ADDENDUM NO. 2

DATE OF ISSUANCE: 7/21/2026

PROJECT: AUTOMOTIVE TECHNOLOGY CENTER RELOCATION AND RENOVATION
8204 HWY 311, SELLERSBURG IN, 47172

ARCHITECT'S PROJECT NO.: 26-064

I 101
PROJECT NUMBER
26-064.002

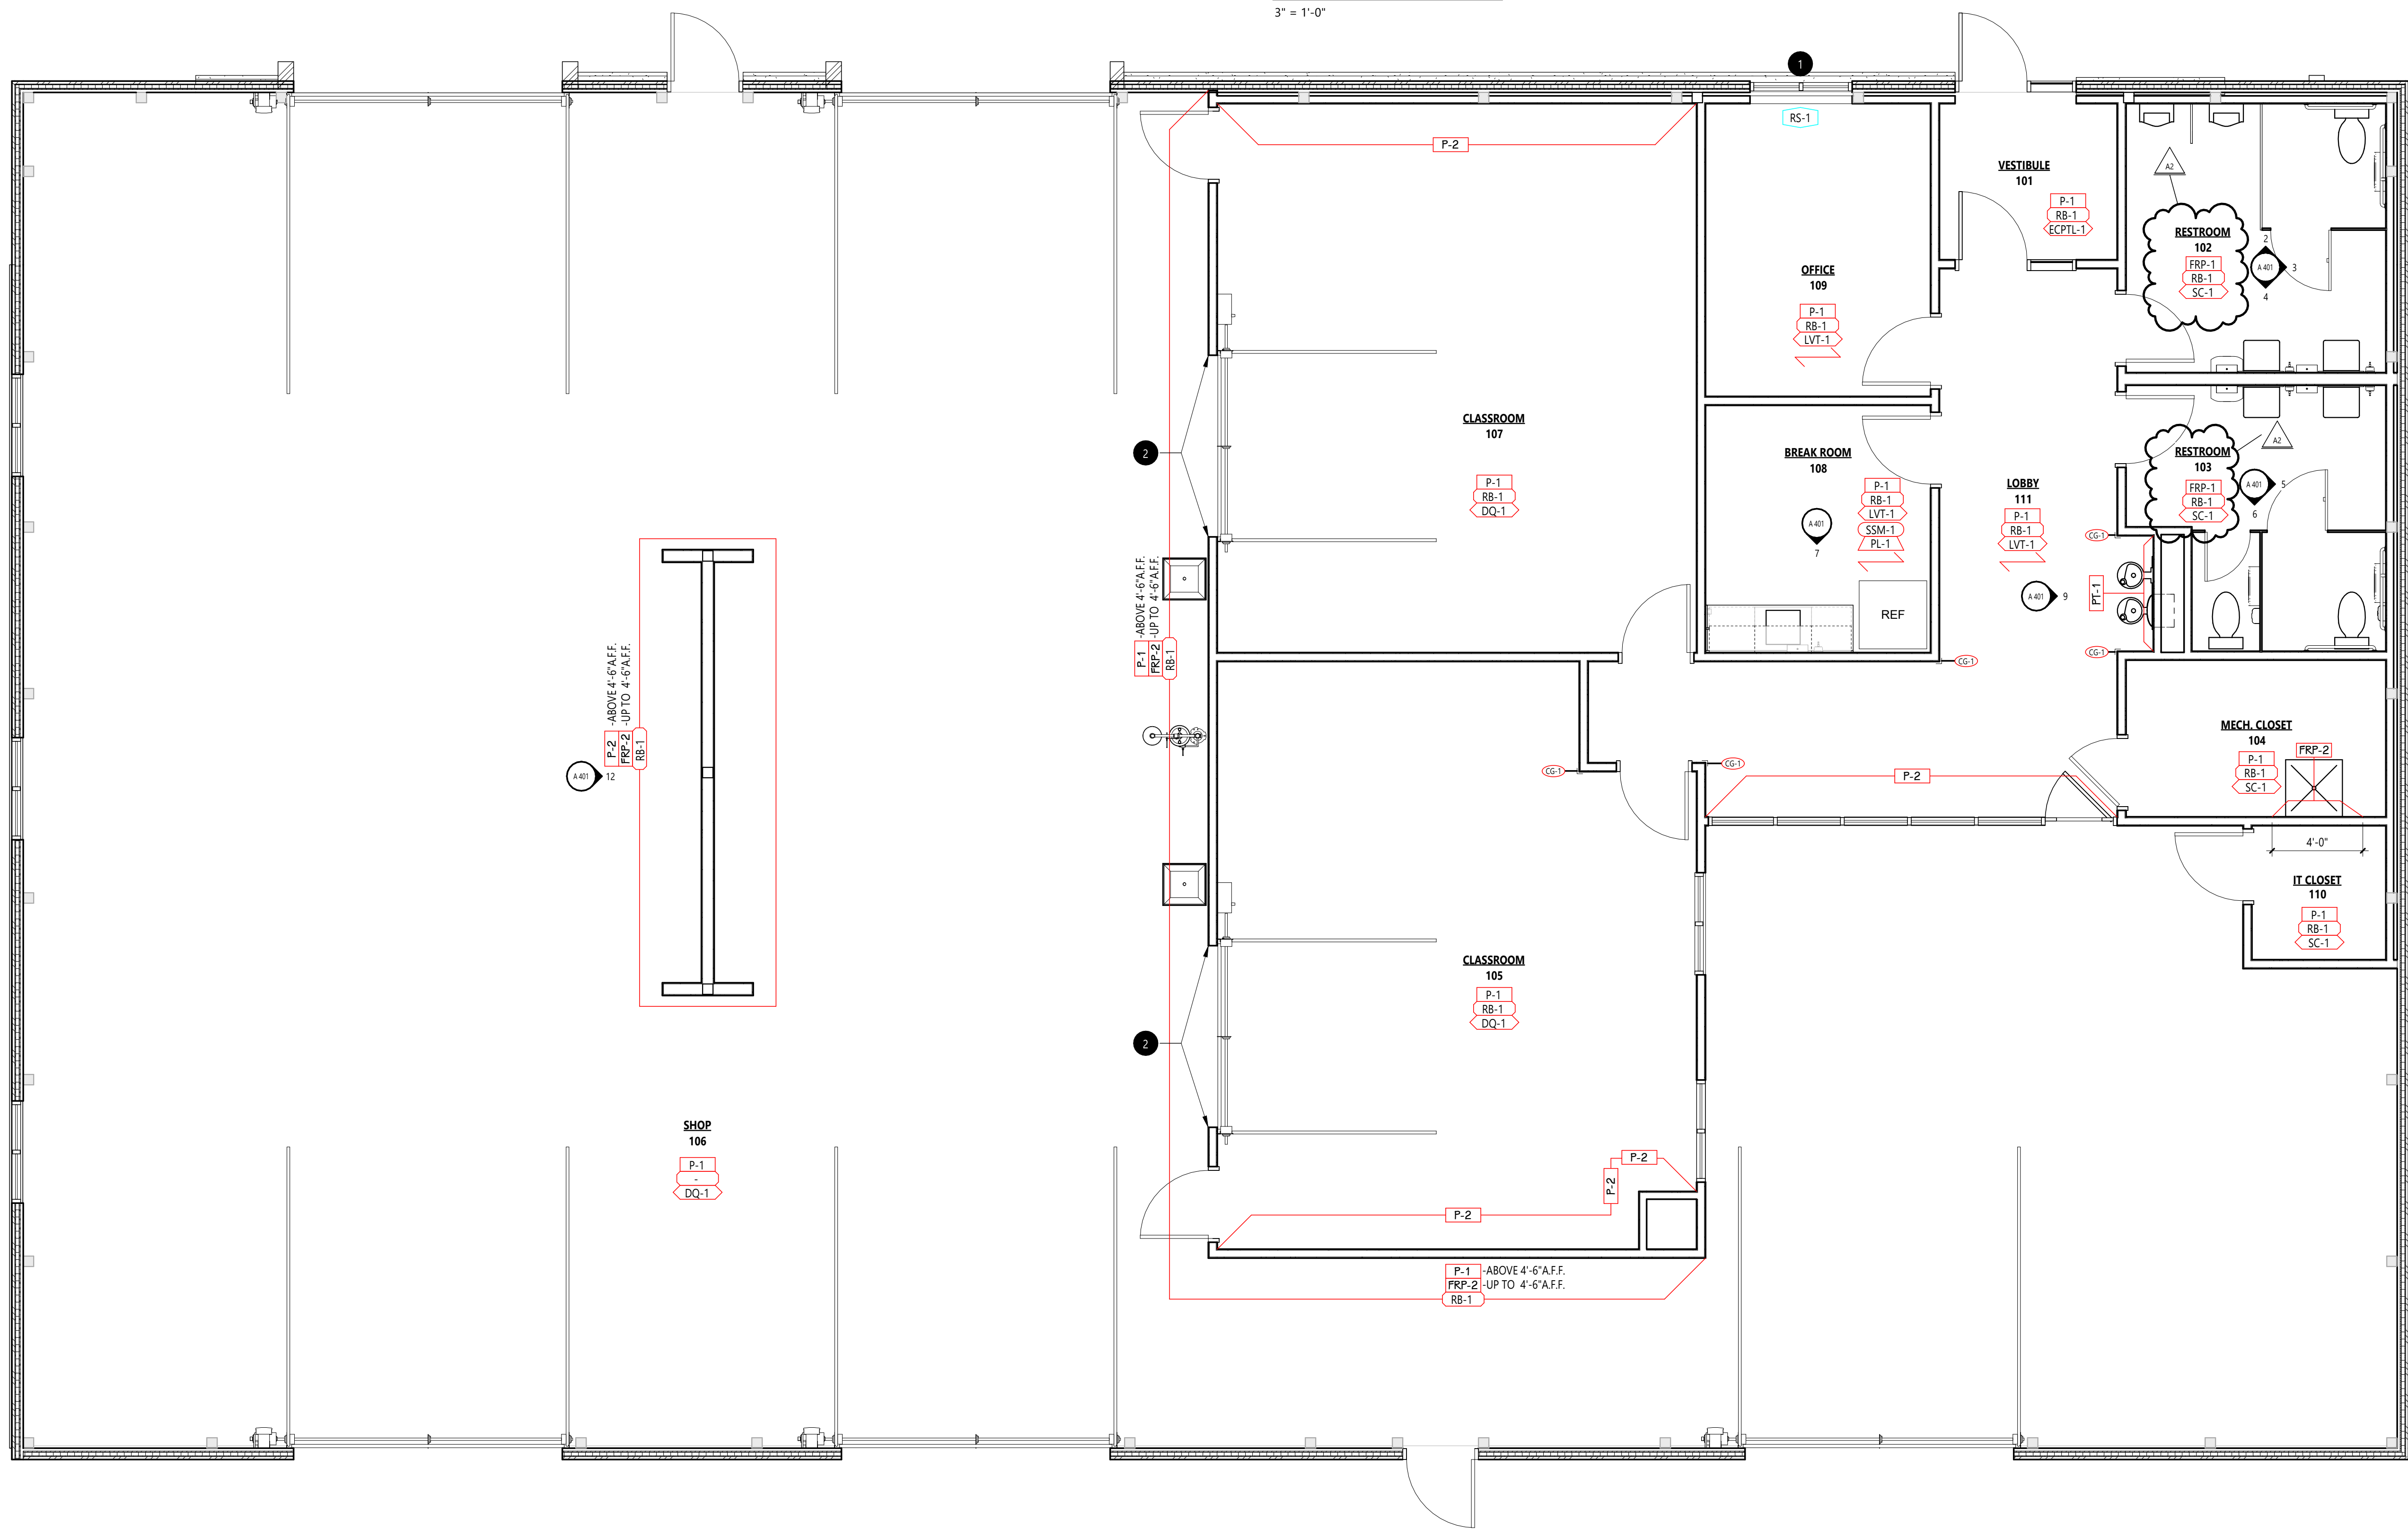
4. The Finish Schedule/ Spec do not provide details for the PC-1 Floor Finish. However, the Restroom Floor is tagged as PC-1 on the drawings. Therefore, for now PC-1 has been assumed to be Polished Concrete as per best understanding.

ADD-2: I 101

Updated floor finish tag

No polished concrete, any PC-1 tag to be changed to SC-1. See attached drawings.
